## POADP APPLICATION

Date Submitted: January 12, 2000 Name of POADP: Pulte Homes – Newby Tract  
 Owners: Pulte Homes of Texas, L.P. Consulting Firm: Brown Engineering Company  
 Address: 1008 Central Parkway South Address: 1000 Central Parkway North, Suite 100  
San Antonio, Texas 78232 San Antonio, Texas 78232  
 Phone: (210)496-2066 Phone: (210)494-5511  
 Existing zoning: Temp R-1 Proposed zoning: R-7 PUD

Re: Pulte Homes-Newby Tract

POADP # 679

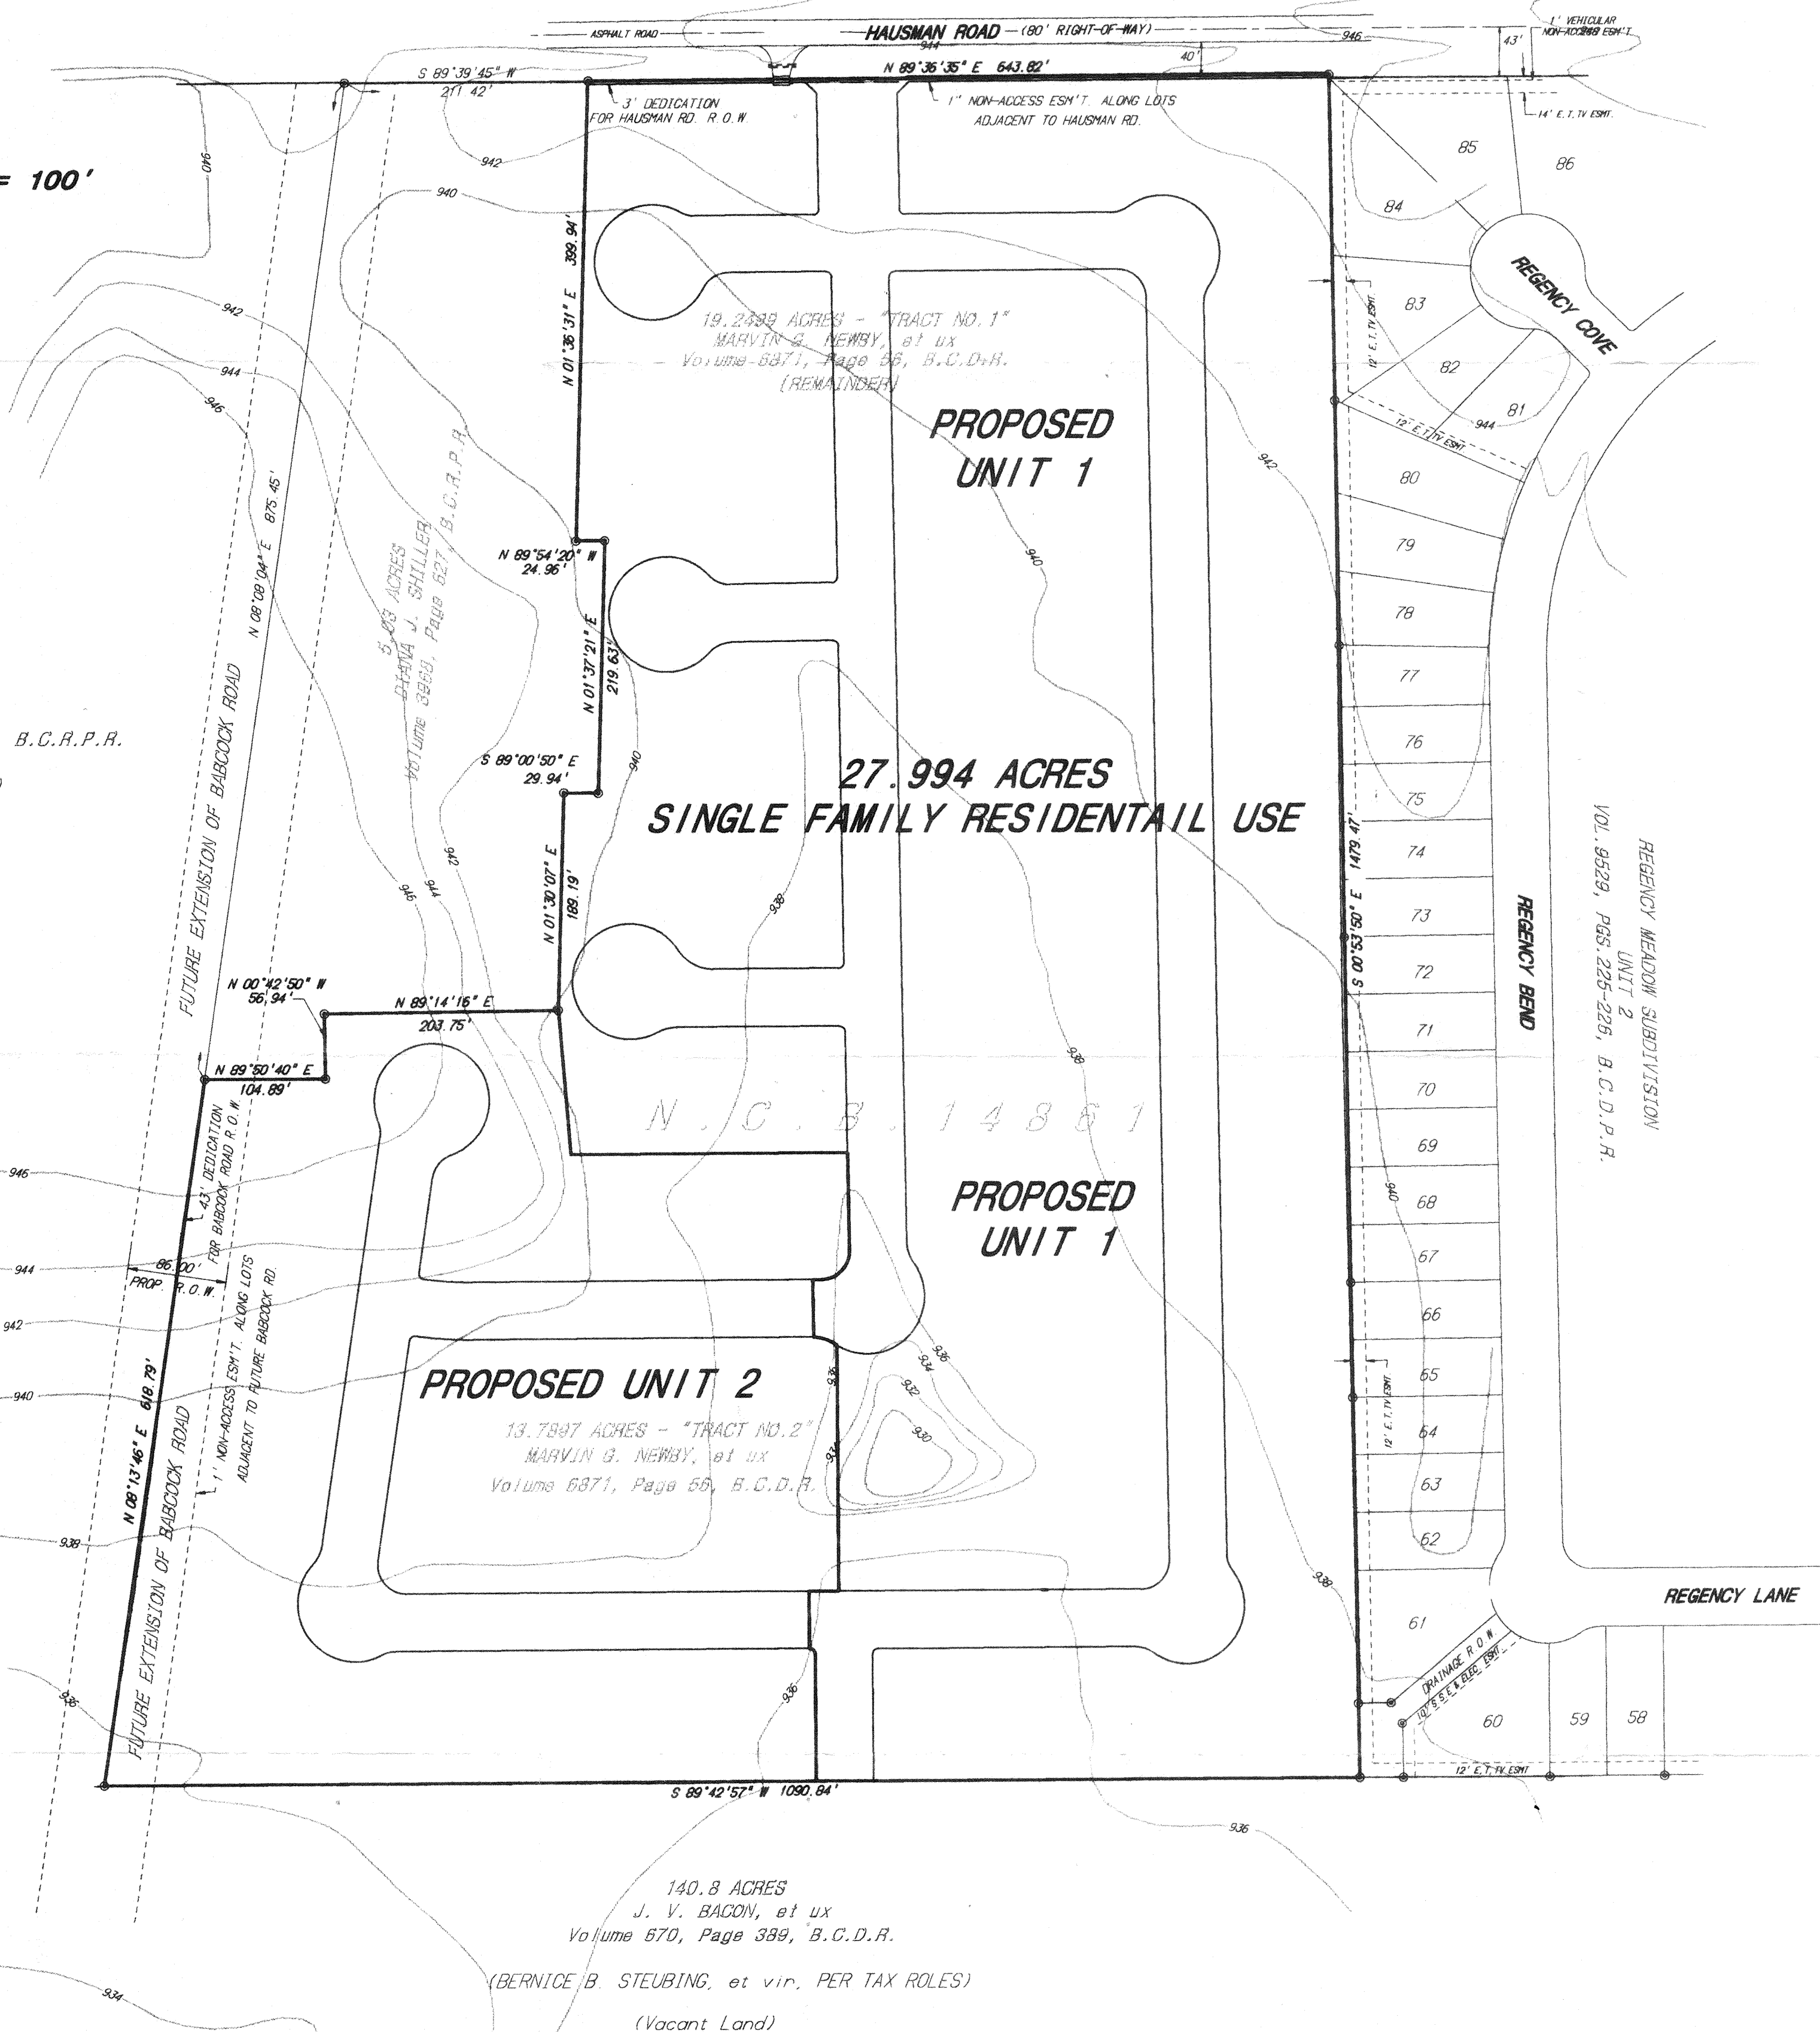
(e) Existing and proposed circulation system of collector, arterial, and local type B Street and their relationship to any adjacent major thoroughfares; and any proposed alternative pedestrian circulation system, was incomplete. **The 43' street dedication for future extension of Babcock Road must be shown on the POADP plan to meet the requirements of the Major Thoroughfare Plan at time of platting.**

(d) Paragraph, (2) The resulting additional ingress and egress of vehicles will seriously disrupt the flow of traffic on the thoroughfare. A 1'-non accesses esm't will be required on the properties adjacent to the proposed Major Thoroughfare. (Extension of Babcock).

3.) Access needs to be provided to the adjoining properties to the south for connectivity.

Comments: HAUSMAN RD AND THE FUTURE EXTENSION OF  
PABCOCK RD. ARE BOTH ON THE MTP REQUIRING A MIN. OF 80'  
ROW.

Comments: BABCOCK ROAD IS A MAJOR THOROUGHFARE SECONDARY  
ARTERIAL REQUIRING A MIN OF 86' R.O.W. Plat need to  
show street dedication for BABCOCK RD.

(e) Existing and proposed circulation system of collector, arterial, and local type B Street and their relationship to any adjacent major thoroughfares; and any proposed alternative pedestrian circulation system. Was incomplete. *The 43' street dedication for future extension of Babcock Road must be shown on plan.*

(d) Paragraph, (2) The resulting additional ingress and egress of vehicles Will seriously disrupt the flow of traffic on the thoroughfare. A 1'-non accesses esm't will be required on the properties adjacent to the proposed Major thoroughfare. (Extension of Babcock).

3) Access needs to be provided to the adjoining properties to the south for connectivity.

The dedication of land for the future extension of Babcock Road has been shown; however the owner is continuing to discuss removal of this requirement with the Director of Planning.
